DESIGN CHANGES

Project	COUNTY FLATS, SANDFIELDS
Project number	N297
Client	HALE CONSTRUCTION LTD
Title	BLOCK 03/04 ELEVATIONS 2/2
Drawing number	A014
Scale	1 : 100 at A1
Revision	H
Status	INFORMATION
Drawn	PC
Date	30.11.21

01 E06 - Block 3 Open Public Space Elevation
1 : 100

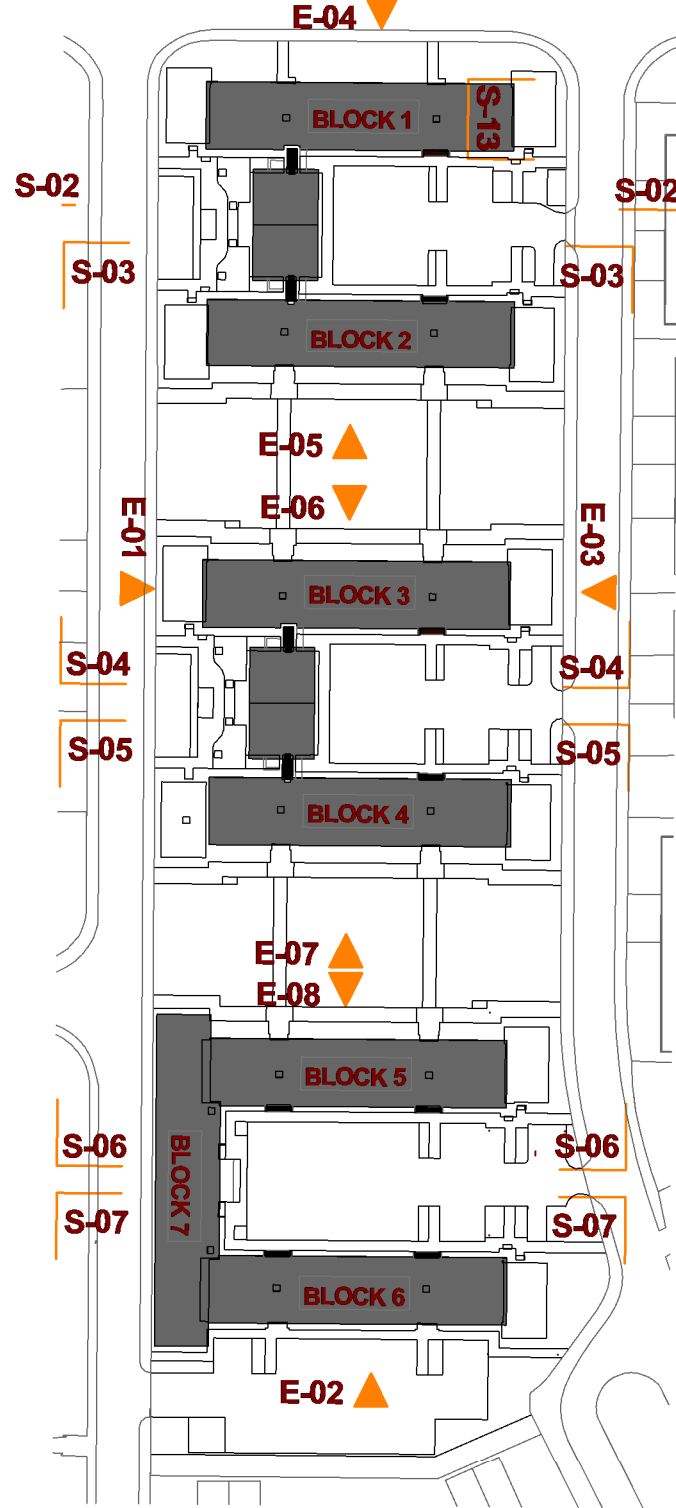
1. Modular end links re-positioned slightly off existing buildings, with the party wall straightened and porch projections aligned with this wall, to ensure modular construction can be achieved off site.

2. Windows have been slightly re-positioned to the new build to suit the structural design of the modular units and the constraints of the timber frame.

3. Parapet to modular end blocks have been lowered by approx 900mm to comply with the structural wind loadings and timber frame design.
4. Corner windows have been removed and replaced with 2no. Windows on either corner, again due to the structural and timber frame design of the blocks.

5. PV panels have been omitted from the end modular units to suit the structural and timber frame design of the blocks.
6. Ground floor Juliet balcony added to existing flats to provide better security whilst ensuring the open areas remain as communal spaces.

7. Air source heat pump external louvre enclosure amended to be single storey over entrance canopy to end link blocks.
8. External air source louvered enclosure handed to provide internal riser/access requirements for maintenance.

9. Buggy/cycle store added to block 6 and 7 parking courtyards.
10. Bin stores slightly re-positioned to suit existing drainage runs, with bin store near block 6 amended in size to suit located of bedroom window.

11. Footpaths amended to be Tarmac.
12. Windows in communal area to the linked blocks made narrower to ensure 1.8m fire separation distance to existing windows is achieved to comply with building regulations.

13. 1no. window in block 7 communal area either side of stairwell removed to ensure 1.8m fire separation distance to existing windows is achieved to comply with building regulations.
